COMMON NON-COMPLIANCES FOUND DURING TFP/FSC CHECKS

MAJ Winson Cheung
Head Permit & Certification
Fire Safety & Shelter Department
Singapore Civil Defence Force

LPG MANIFOLD SYSTEM

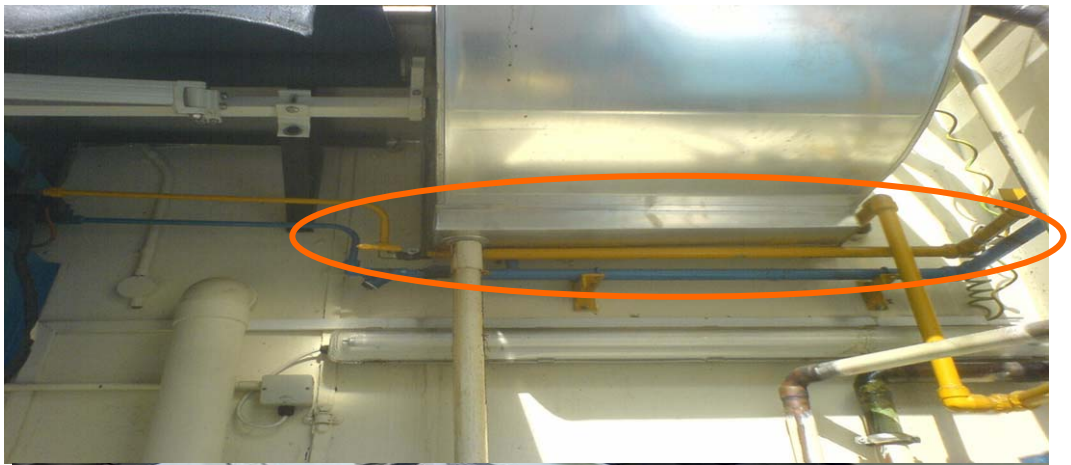
- **Appendix M – Outdoor / Indoor LPG cylinder installations**
- **NFPA 54 and NFPA 58**
- **The emergency shut-off valve and extinguisher**

- **3m from the LPG cabinet (0.5 m at site)**

TOILET
COLD ROOM
MALE TOILET
FEMALE TOILET
OPEN TERRACE
BALCONY
KITCHEN
STAIRCASE 2
STORE
STAIRCASE 1
2
Staircase 2 at 2nd storey was not protected
2nd storey
BALCONY

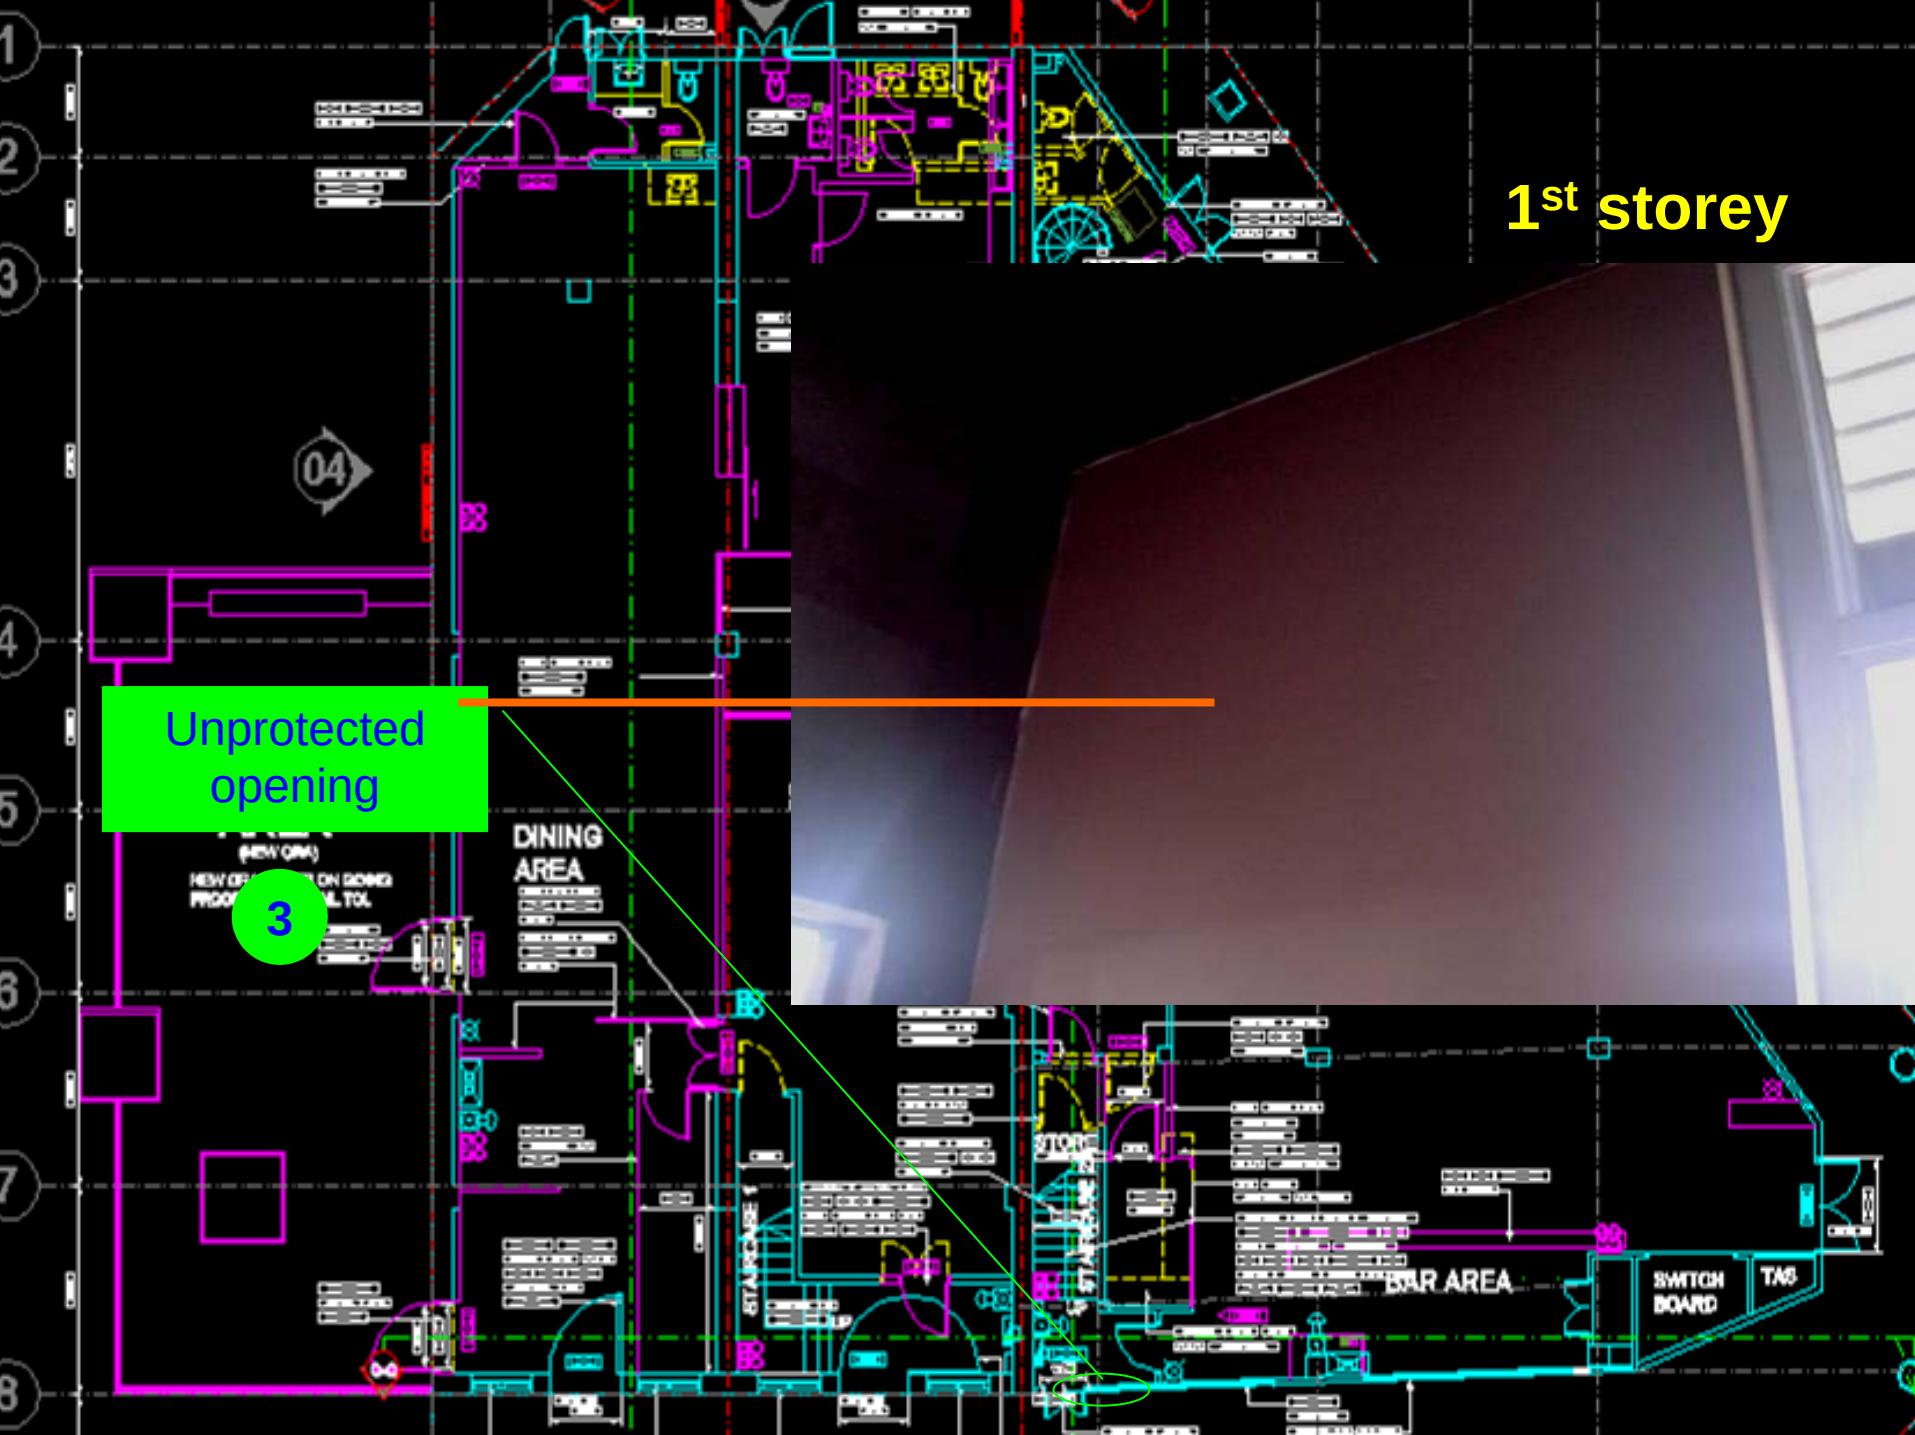
1st storey
Unprotected opening
3
DINING AREA
BAR AREA
SWITCH BOARD
TAB

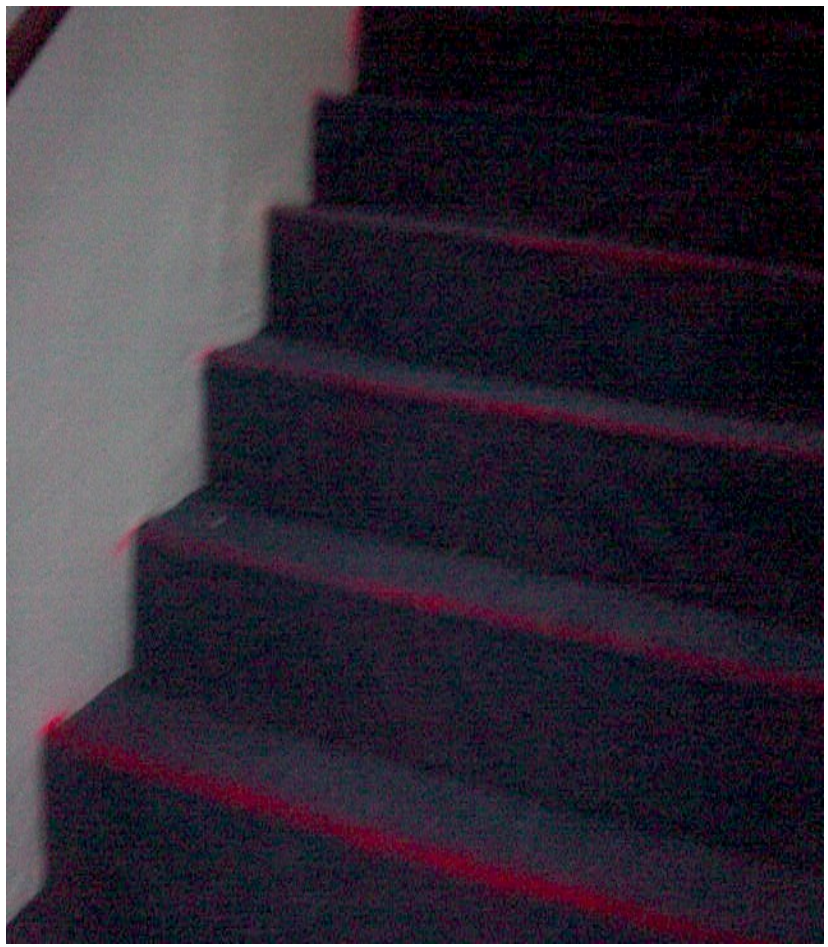
Glass door installed at exit staircase, not fire rated and no waiver being sought

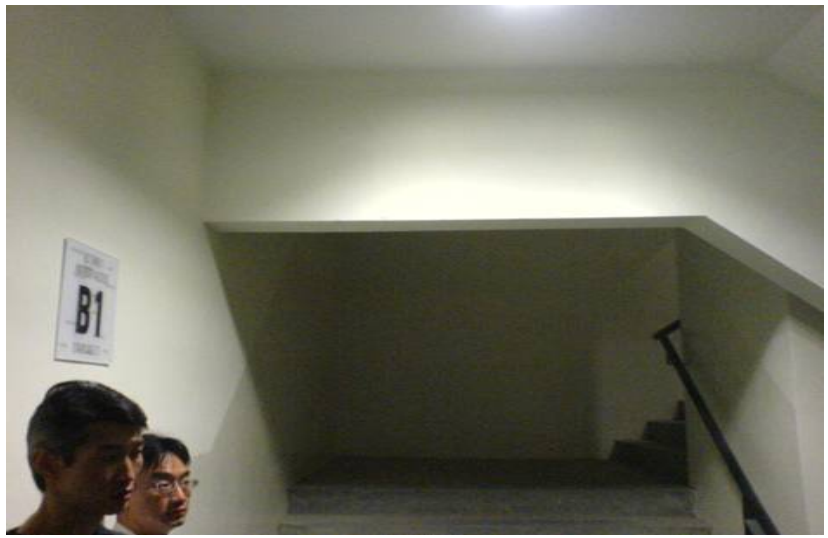
–**Absence / insufficient of directional exit signs**

– **Fire extinguishers not unwrap, not hung**

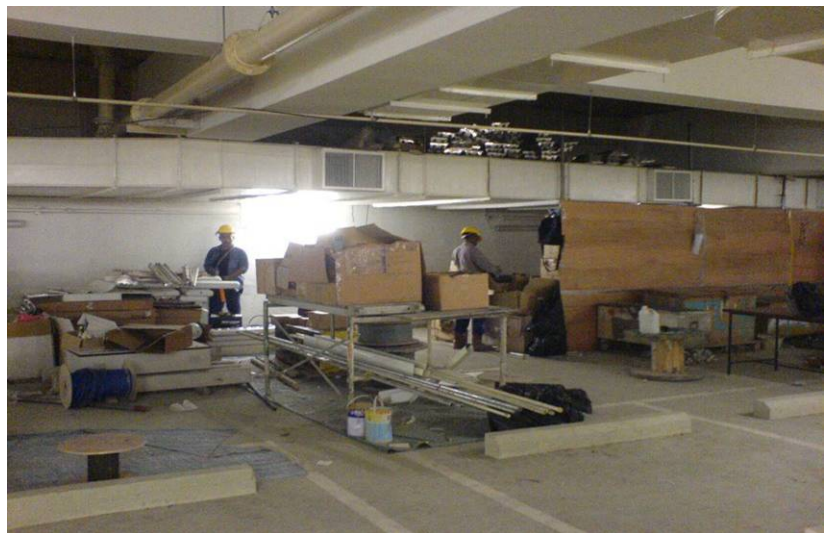
Fire hazards not removed after building completion
